Kyrene, Roosevelt, Farmer Bike/Ped Improvements Project Public Input Summary May 2023

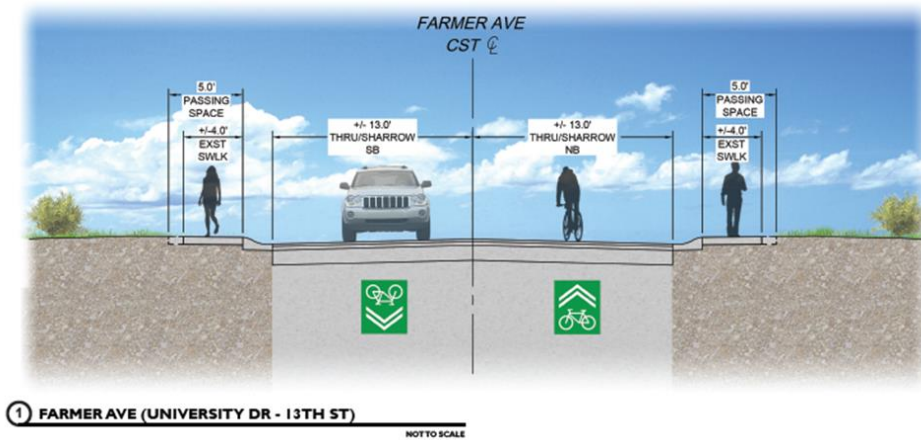
1. Farmer Avenue from University Drive to 13th Street is proposing to add shared-lane markings to the roadway. Please share your thoughts on the Farmer Avenue from University Drive to 13th Street segment.

1. Advisory bike lanes on this section would be nice. would not impact road use or access in the neighborhood and provide more visual cues to yield to cyclists.

2. <https://www.peopleforbikes.org/news/we-were-wrong-about-sharrows>. Add modal filtering to prevent cut-through traffic
3. I am in support of this plan

4. I assume the traffic calming features will stay in place. I am in favor of the sharrow which gives drivers a reminder to share the road with cyclists with such limited space.

5. I like the addition of the shared lane markings.
6. I like the idea for putting in sharrows since there isn't room to actually expand the roadway.
7. I think this plan is even worse than the N/S Multiuse path plan. Back to the drawing board. I think that whomever was at the Zoom meeting had a great idea of going from Hardy all the way down to the canal and crossing at the canal at Kyrene and Baseline and then continuing down the canal. Solves a lot of problems. Your idea of going through Dwight Park is absolutely not going to work.

8. I'm in strong favor of this. If there's any way to create a barrier between the bike lane and vehicles, that'd make it even more enjoyable and safe to use. Although, I understand the feasibility of that given the space is likely difficult.

9. It is best to have clear markings if it is a shared lane.
10. It would be have a separate bike lane. How is the city going to deal with the people that park on Farmer?

11. OK
12. please explore low level lighting in the chicanes- maybe spruce up the existing landscaping a bit where trees may be missing.
13. Please use more signage and paint more green indicators on the ground so motorists know to share the road. Signs that say "motorist MUST not road rage on cyclists" would be nice.

14. Pretty narrow street so this is the best option - I already ride my bike down the street a lot but nice to make it clear it is a shared space and people in cars should drive accordingly

15. Shared-lane markings should be placed before each chicane along Farmer for increased visibility of cyclists and so drivers know bicyclists need to move into the center of the road too.

17. The existing traffic calming narrowing devices force auto and bicycle traffic to merge. This will remain dangerous regardless how well the the narrowing devices are highlighted (reflective paints etc.). If there was room on the sidewalk side of the narrowing devices for the bike path, that would be useful (currently that is not an option unless the bikes share the sidewalk). For the person on the bicycle currently "watch out for the cars" or "watch out for the pedestrians" - there is no exclusive way past the narrowing devices on Farmer.

18. There is no purpose in adding sharrows here, as vehicle traffic should already be slow enough to have mixed traffic with no issue. The function of the street will remain the same.
 19. This is a neighborhood street so the sharrows make sense.
 20. This is not heavily traveled, but many bicyclists might try to ride on the sidewalk, not sure if you have any data on the safety of the sharrow lanes.
 21. With all the buses and cut through traffic there should be more traffic coming or no-parking/protected bike lanes in this section of road.
2. 13th Street from Farmer Avenue to Roosevelt Street is proposing to maintain the existing bike lanes and vehicular travel lanes. Please share your thoughts on the 13th Street from Farmer Avenue to Roosevelt Street segment.

② 13TH STREET (FARMER AVE - ROOSEVELT ST) NOT TO SCALE

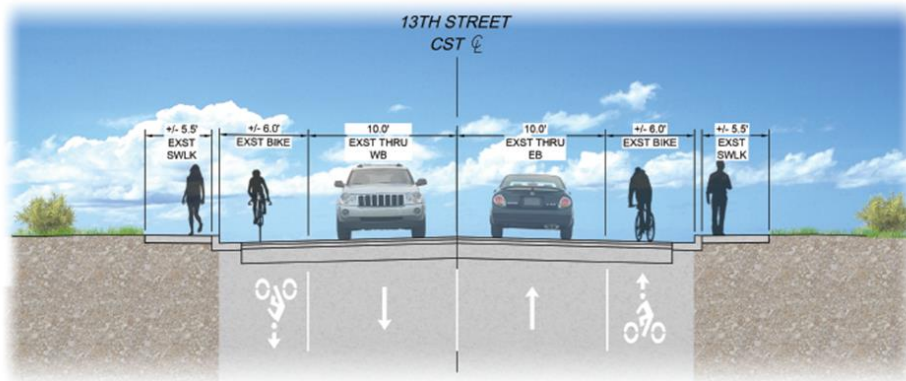
1. Add high-vis green paint to more sections of the bike lane along 13th.
2. As someone mentioned in the Zoom meeting, traffic sign enforcement at the stop signs at Farmer and 13th street, and 13th street and Roosevelt is needed currently. People regularly run through these stop signs. The Venus Orbit circulator bus drivers can supply more data regarding this.

3. Bike lanes near ASU are preferred.
4. fine with this segment.
5. I agree it makes sense to maintain since the infrastructure is already there for a dedicated bike lane in each direction.

6. I am in support of this plan
7. I would appreciate if there could be some green paint to signify the bike lane here, whole lane or sections.
8. I'm in strong favor of this. If there's any way to create a barrier between the bike lane and vehicles, that'd make it even more enjoyable and safe to use.

9. OK
10. Painted bike lanes are acceptable on this street, because traffic is slow. However, the painted line approaching intersections should become full, instead of dashed.

11. Please do not have the bike lane paint turn to dotted lines at intersections and put in green paint at intersections.
12. Please paint most of bike lane green and CLEAN all bike lane. Most of the trash is pushed over into the bike lanes forcing us to ride in the street or on the sidewalk to avoid debris.

13. Protect the bike lane!
14. That should work fine.
15. This bike path should go Farmer to 13th to Hardy.

- 16. This is a place where cars do not notice bikes. Make the lanes more visible
- 17. This is a short section and the existing infrastructure makes sense.
- 18. this works

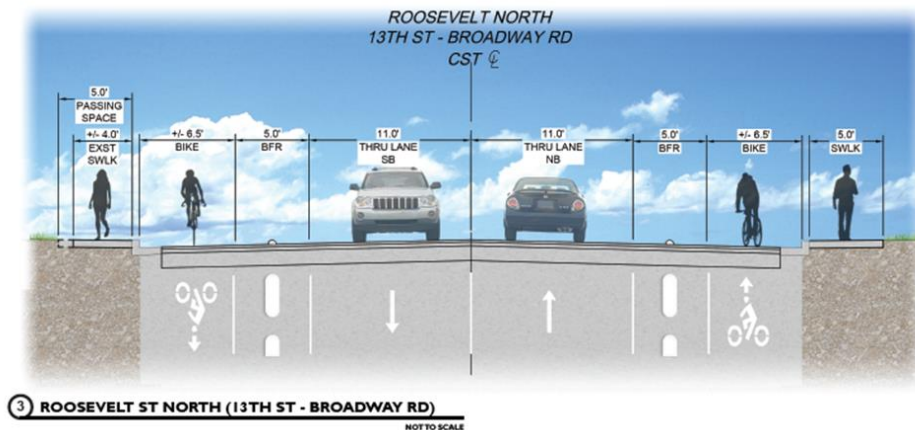
- 3. Roosevelt St. from 13th Street to Broadway Road is proposing to remove the center turn lane to add a 5' buffer space between the vehicular and bike lane. Within the buffer space a raised channelization device is proposed (gaps will be provided for access to driveways, streets, alleys, and transit stops). In addition, new sidewalk is proposed where sidewalk is currently missing. Please share your thoughts on the Roosevelt St from 13th Street to Broadway Road segment.

- 1. Adding barriers to the bike lane and adding a side walk is a good idea for this road - it is in a neighborhood and there should be a sidewalk on both sides.

- 2. Can we add some planted medians in specific locations? Trees and shrubs in the buffer would be great! Shade! This segment has tons of room- skinny up the travel lanes if you need to- anything to slow down the cars. Maybe add one of the new transit shelters in tis location near Clark Park?

- 3. Don't remove traffic lanes! Just Say No to buffered bike lanes! They are dangerous for cyclists. What do you do when there is debris in the bike lane? You crash into the debris, or into the buffer. This segment is not needed and cyclists will not use it. Hardy is the preferred route that cyclists know and use.

- 4. Good to add sidewalks. Concrete bollards
- 5. I am in favor of removing the middle turn lane to add safety measures for cyclist with a 5' buffer. Having a buffer is the most effective way to protect cyclists from vehicular traffic while still giving access to driveways and alleys. The need for a continuous sidewalk is paramount for accessibility and safety.

- 6. I am in support of this plan
- 7. I am pleased to see this design that protects the both the walker and the biker. Thanks so much for completing the missing sidewalk segments. It will do such much to protect our neighbors. Thanks!!!

- 8. I don't think the buffered part of the lanes should be anything that drivers could drive over easily. I would feel safer if the barrier was higher and made of sturdier material.

- 9. I like that Roosevelt (13th Street to Broadway) will have sidewalks and protected bike lanes on each side of the street.
- 10. I realize the city already owns the east side of Roosevelt where sidewalks are proposed and therefore the city can do whatever it pleases on this strip of land. I just hope someone from the city is contacting the residential land

owners along the east side of Roosevelt to discuss this plan in detail. I am one house removed (further east) so I would not be in the directly affected group of home owners.

11. I think the buffer takes up too much space. If it was reduced to 2' in each direction (like the Alameda to Southern segment), a middle turn lane could still be maintained.

12. I would suggest putting both bike lanes on the same side, bi directional. This could save some space for parking on one side of the road. maybe make the buffer ridged and smaller than 5 feet wide.

13. Oh my gosh, a barrier between bikes and cars, I love it, yes please - I would love to see more of this "actual barrier approach" between cars and bikes - so much safer!

14. OK
 15. Paint bike lanes green. Please use more signage and paint more green indicators on the ground so motorists recognize and look more often.
 16. Personally have needed/wanted a sidewalk and bike lane in this area.

17. Please consider adding vertical elements to the channelization devices in the road. Why not add them? They increase visibility with reflectors at night.

18. Removing the center turn lane is a good idea, but the buffer would be better if it included a full curb, not small bumps that cars could still go over.

19. This is a good treatment.
 20. this part of Roosevelt is probably wide enough to remove the center turn lane, even with improvements at Clark Park.

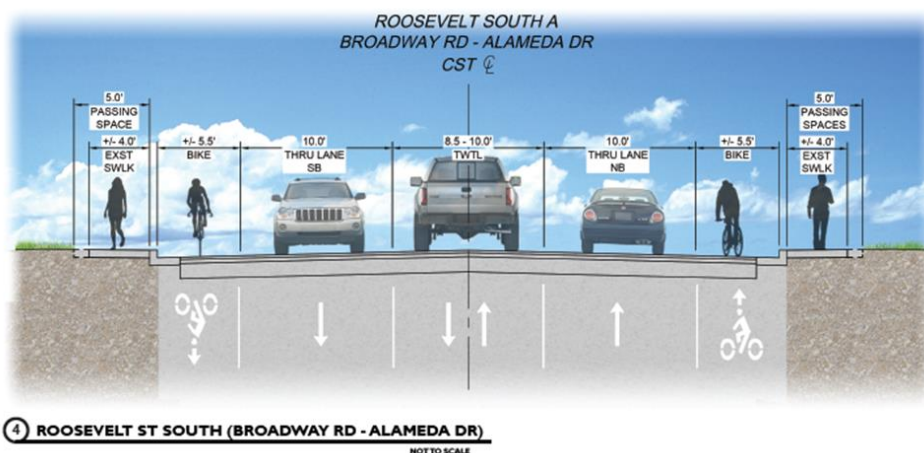
21. Yes, yes, yes! I bike this regularly and this is desperately needed to make the route safer.
4. Roosevelt Street from Broadway Road to Alameda Drive is proposing standard bike lanes. Please share your thoughts on the Roosevelt Street from Broadway Road to Alameda Drive segment.

1. A buffered bike lane would be better. But a bike lane is a great start
2. A proper bike line on this road will be helpful but it would be nice to have a barrier. This section of the road has fast traffic.
3. A small physical buffer for bicycles would be ideal. Some traffic calming like speed humps or chicanes to keep vehicles at safe speeds would also be nice.
4. Again, anything with a buffer between the bike lane and vehicles is ideal.
5. I think a protected bike lane should be considered for this section. There is large amount of industrial semi-truck traffic which have large drafts that can

make a cyclist waver in their path, it would be better to have a barrier like the section proposed north of Broadway Rd.

6. I wish this section also had a buffer, seems odd to not add it only for this section. Would appreciate green paint to signify bike lane.
 7. I would like to see center medians have trees/landscape

8. I would love to remove the center lane here as well and create the actual barriers between bikes and cars, if possible.
 9. Looks good. I would assume this fits in with the gargantuan three story mega apartment monolith just completed on the SW corner of Broadway and Roosevelt.

10. Make sure the gutter isn't considered part of the bike lane
 11. Not needed.
 12. OK
 13. ok with this segment
 14. Protected bike lanes and paint bike lanes green. Please use more signage and paint more green indicators on the ground so motorists recognize and look more often.

15. Protected/ buffered lanes would be better
 16. Roosevelt St. needs bike lanes.
 17. This portion of Roosevelt has a lot of semi trucks. It would be better to have a barrier for the bikes. Also the when truckers make a rt turn from Broadway to turn south on Roosevelt, the corner is too tight. The trucks have to take up both lanes to make a right hand turn. For a business district - consideration of how trucks turn should have been included in the design of the corners.

18. Your idea of upsetting all the trucks that park in the middle lane of S. Roosevelt south of Broadway is preposterous. You cannot take out the middle lane because these trucks unloading and loading have to wait sometimes for a considerable length of time and to have them cut through the bike lane to get to these companies is really asking a lot of this business neighborhood.

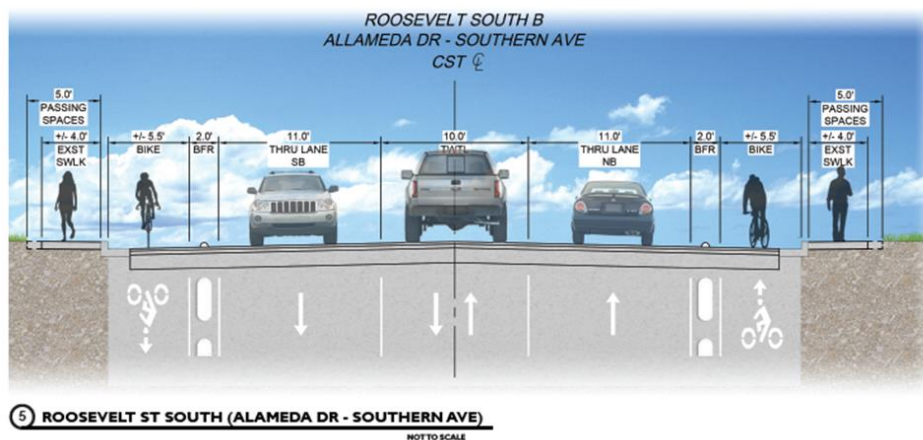
5. Roosevelt Street from Alameda Drive to Southern Avenue is proposing bike lanes and a 2' buffer between the vehicular and bike lane. Within the buffer space a raised channelization device is proposed (gaps will be provided for access to driveways, streets, alleys, and transit stops). Please share your thoughts on the Roosevelt Street from Alameda Drive to Southern Avenue segment.

1. As this stretch of the road isn't as busy as others, I think the 2' buffer is fine here.

2. buffers are a good idea where infrastructure and space allows.
3. Good treatment
4. Good..That's a better design to have "bike buffer"
5. I am in favor of this plan because of the industrial and semi-truck traffic having a barrier for cyclists would feel much safer and give some distance for the truckers for their maneuvers.

6. I am in support of this plan
7. I believe channelization is needed because of the industrial areas.
8. I prefer this to help with congestion and left-hand turns down Roosevelt.

9. I would like to see center medians have trees/landscape
10. Just Say No to buffered bike lanes! They are dangerous for cyclists. What do you do when there is debris in the bike lane? You crash into the debris, or into the buffer.

11. Looks good.
12. Love it!
13. Paint bike lanes green. Please use more signage and paint more green indicators on the ground so motorists recognize and look more often.

14. Please consider adding vertical elements to the channelization devices in the road. Why not add them? They increase visibility with reflectors at night.

15. Safety along Baseline is key and is missing. It would be key to start there ASAP.
16. Sidewalks needed just north of Southern to Fairmont. But looks good

17. The buffer device will be important for improving safety.
18. The buffer should be a full curb instead of a small bump. Additionally, the bike lane must be reworked at the approaches to, and within signalized intersections. The bike lane simply ending before a traffic light is unacceptable.

19. Yes, I love the specific barrier - I would feel safer, as a bike rider.

6 ROOSEVELT ST SOUTH (SOUTHERN AVE - DWIGHT PARK)
NOT TO SCALE

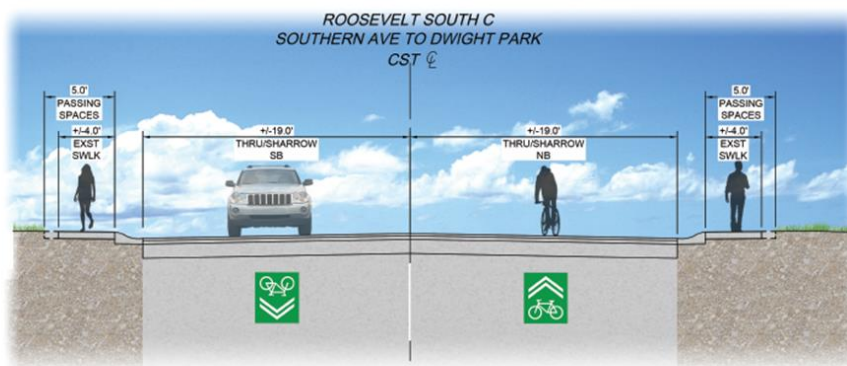
6. Roosevelt Street from Southern Avenue to Dwight Park is proposing to add shared-lane markings. Please share your thoughts for the Roosevelt Street from Southern Avenue to Dwight Park segment.

1. Again, anything with a buffer between the bike lane and vehicles is ideal.
2. Bike lanes
3. I am in support of this plan
4. I like the addition of shared lane markings. This road isn't too busy so don't mind sharing the road but bike lanes will always be preferred.
5. I like this option because it won't cause issues for residents due to construction.

6. It is best to have clear markings if it is a shared lane. However, these marking should continue to Hardy. Many cars speed in this area and do not look for pedestrians or bicycles.

7. Looks good.
8. Not needed since Hardy already has bike lanes.
9. OK
10. Please use more signage and paint more green indicators on the ground so motorists know to share the road. Signs that say "motorist MUST not road rage on cyclists" would be nice.

11. Sharrow lanes do not change the function of the street. If traffic is slow enough (which it is here), bikes and cars can safely share the space.
12. Sure

13. That should work - there is less traffic on that segment.
14. This area of Roosevelt is under construction with 3 new Habitat for Humanity housing. More apartments are going up on the corner of S. Roosevelt and Southern so the parking will be pretty dense. This idea is just poorly thought out. Have you talked to the Deputy Director of Parks about your plans because they are installing a granite walkway in there where you are planning to put your bike path and 14 new lights to be installed in the summer of 23. You all need to talk to each other.

15. This is not heavily traveled, but many bicyclists might try to ride on the sidewalk, not sure if you have any data on the safety of the sharrow lanes.

7 MANHATTAN DR (DWIGHT PARK - KYRENE RD)
NOT TO SCALE

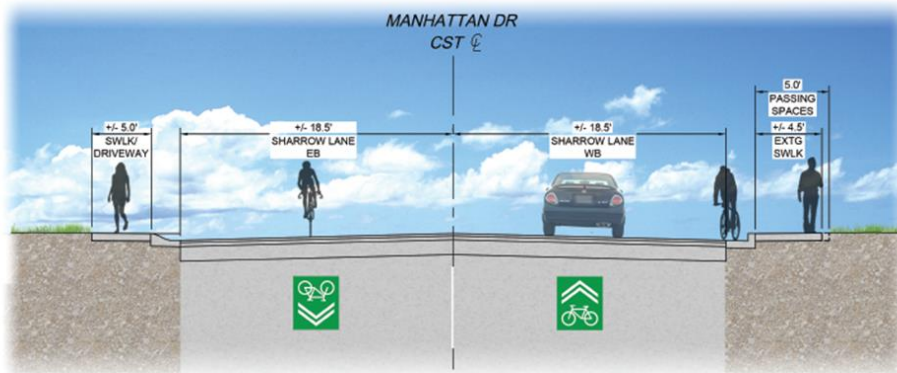
7. Manhattan Drive from Dwight Park to Kyrene Road is proposing to add shared-lane markings. Please share your thoughts for the Manhattan Drive from Dwight Park to Kyrene Road segment.

1. Adding a simple bike lane or shaded lanes does not really make for a "good" bike route. Buffered or physically divided lanes would be best. The original plan to use the UP ROW would have made for a route free of car traffic, the alternative should provide a similar level of separation.
2. Again, anything with a buffer between the bike lane and vehicles is ideal.
3. Bike lanes
4. I am in support of this plan
5. I don't particularly want the side walk in front of my house made wider. I have brick pillars and wrought iron fence next to the current sidewalk. What happens to that??
6. I like the addition of shared lane markings. This road isn't too busy so don't mind sharing the road but bike lanes will always be preferred.

7. If there's 18.5' travel lanes, why not a marked bike lane?
8. It is best to have clear markings if it is a shared lane.
9. Looks fine
10. Looks good.
11. Manhattan Drive (Please see that your spelling is incorrect) at the juncture that you will cut through from the park is not practical. These are private homes for the most part and the additional people coming through this neighborhood would be frowned upon. There are speed humps on this street as well as new construction on Kyrene adding 3 hours that face Kyrene. At the moment there are multiple parties in these houses (one on Manhattan as well) where as many at 1000 people attend. How would that work?

12. OK
13. Please use more signage and paint more green indicators on the ground so motorists know to share the road. Signs that say "motorist MUST not road rage on cyclists" would be nice.

14. Sharrows do not change the function of the street.
15. Sure
16. This is not heavily traveled, but many bicyclists might try to ride on the sidewalk, not sure if you have any data on the safety of the sharrow lanes.

17. This segment is not needed. It doesn't go anywhere useful for cyclists.
18. Will there be a path through Dwight Park off Manhattan Drive, or are cyclist's supposed to take the streets that surround the park to get from Roosevelt to Manhattan Drive?

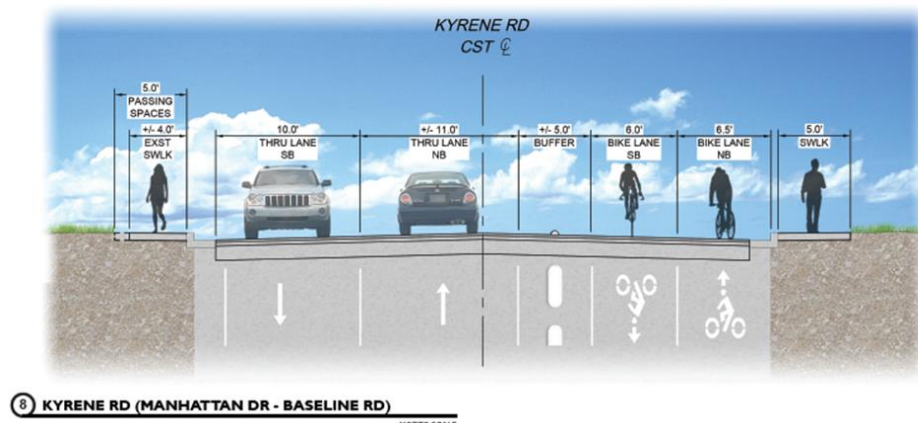
8. Kyrene Road from Manhattan Drive to Baseline Road is proposing to replace the standard bike lanes with a 2-way cycle track on the east side of the road. A buffer of 5' is being proposed between the vehicular lane and cycle track. Within the buffer space a raised channelization device is proposed (gaps will be provided for access to driveways, streets, alleys, and transit stops). Please share your thoughts for the Kyrene Road from Manhattan Drive to Baseline Road segment.

1. Given the speeds on this road, the 2 way cycle track will be valuable for safety.
2. Great place for our first real cycle track! Plant the buffer! This section needs extra love!
3. Hmmmm...I'm not sure about having the 2 way cycle track.
4. I am in support of this plan
5. I don't think this is a good idea because this is the only segment of the route that uses a 2-way cycle track. I think it will be confusing for both motorists and

cyclists. I recommend using the traditional bike lanes that are the same as the ones in other parts of the proposed route.

6. I have concerns for how bike will get from the north side of Kyrene and Baseline to the south side (access to Kiwanis). I also have concerns about the bike lanes being on the east side closest to the railroad tracks.

7. I like that the cyclists are protected from traffic assuming the speed limit will not change on that street. It is interesting that vehicles and cyclists are separated by one barrier instead of using two barriers and the direction of travel for bikes and cars the same (see Roosevelt Rd between Alameda Rd and Southern Rd). It seems like having the road divided in this way causes more cycle crossing traffic.

8. I think the buffer could be bigger here. It will feel odd to be riding into traffic going south. I also think that the buffers should have about a 3 foot tall metal box with top open where later landscaping would be added. Having a tall, sturdy buffer here will make me feel more comfortable while riding south.

9. Ideally the buffer would have a physical divider.
10. I'm not fond of NB & SB bike lanes being next to each other. I feel it's safe to have SB bikes next to SB cars as movement is more predictable to both drivers and riders.

11. Looks good.
12. Looks good.
13. Love it!
14. Needs more attention at Baseline crossing
15. Paint bike lanes green. Please use more signage and paint more green indicators on the ground so motorists recognize and look more often. Shade in some form would be great. What about large planters as a buffer? Also, please make sure to clean the bike lanes otherwise cyclist will choose to ride on the road section for cars or the side walk.

16. Please consider concrete-reinforced steel bollards here - would it much more comfortable for all riders.
17. The buffer must provide a larger barrier between cars and bikes. These small bumps are not enough.

18. The two-way cycle track section absolutely needs vertical bars on the channelization devices. As stated previously, they help increase visibility and contribute to driver awareness that it's a completely separate no-go lane for them. That, and every other city that has two-way cycle tracks has vertical posts delineating them. Let's do our first two-way cycle track right and get the vertical posts in there, and take it as a learning opportunity to see how they work for our city. Worst case scenario they can always be removed, so please include them in the project to start!

19. There is a surprising amount of traffic that goes down Kyrene between Manhattan and Baseline, plus the train tracks run parallel to the road. I'm not sure if having a pedestrian sidewalk the furthest east makes sense because of the train tracks.

20. This road is almost an expressway. I do like the 2-way cycle track as seen on the Mesa Connector project and feel it will reduce speeds. adding a sidewalk on the E side will also help pedestrians.

21. Why do we need a cycle track dead ending at Baseline where the canal and the RR tracks mess everything up? I cannot think of a worse place to put a bike path. Delete this segment and use Hardy south of Manhattan which is ALREADY THERE.

22. Why?! Just make bike lanes cars move way to fast and everyone will be confused.
23. Wow, this would be ideal, I love it!
24. Your plan to come right up to the edge of the UPRR ROW is going to be very interesting considering that their ROW is now 10 feet more (5 feet more from the center of the rails on each side for a total of 25 feet). That makes it a little tight.. If people step onto this property, there will be hell to pay from the UPRR to the City and that relationship is always rocky at best. The homeless garbage dumps will continue and be unsightly. Have you contacted Rosa Inchausti about this? She has been working with the UPRR since last September trying to create a better relationship. Not working at present.
